ADDENDUM #1
PIONEER PARK INTERPRETIVE TRAIL
Inquiry No. 24-101
City of St. George, Utah

February 6, 2024

4 PAVILION FOOTING DETAIL (OP-2)

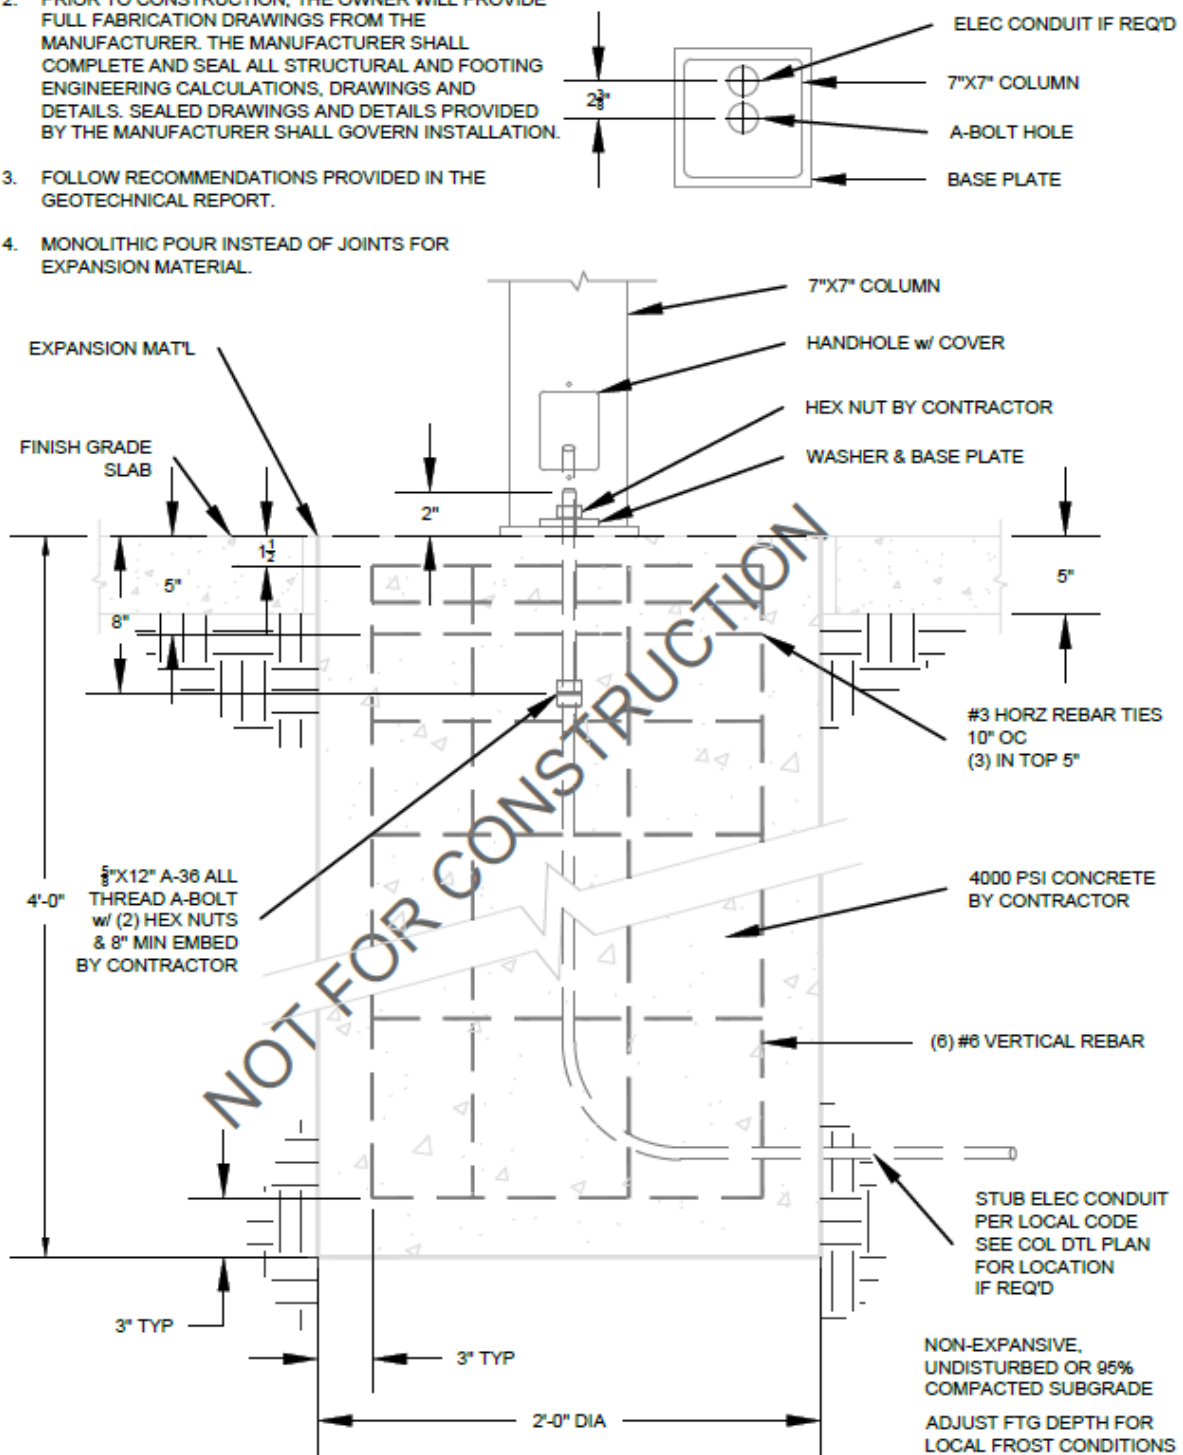
- a. Shade Structure Footings. Use the pavilion footing detail options below to aid in preparing costs for Base Bid Item Number 17 – 12'x15' Shade Structure (Install Only) and Base Bid Item Number 18 – 25'x30' Shade Structure (Install Only):

1. THE FOOTING DETAILS FOR THE PAVILION CONTAINED HEREIN ARE FOR ILLUSTRATION PURPOSES AND TO CONVEY THE INTENT OF THE OWNER.
2. PRIOR TO CONSTRUCTION, THE OWNER WILL PROVIDE FULL FABRICATION DRAWINGS FROM THE MANUFACTURER. THE MANUFACTURER SHALL COMPLETE AND SEAL ALL STRUCTURAL AND FOOTING ENGINEERING CALCULATIONS, DRAWINGS AND DETAILS. SEALED DRAWINGS AND DETAILS PROVIDED BY THE MANUFACTURER SHALL GOVERN INSTALLATION.
3. FOLLOW RECOMMENDATIONS PROVIDED IN THE GEOTECHNICAL REPORT.
4. MONOLITHIC POUR INSTEAD OF JOINTS FOR EXPANSION MATERIAL.
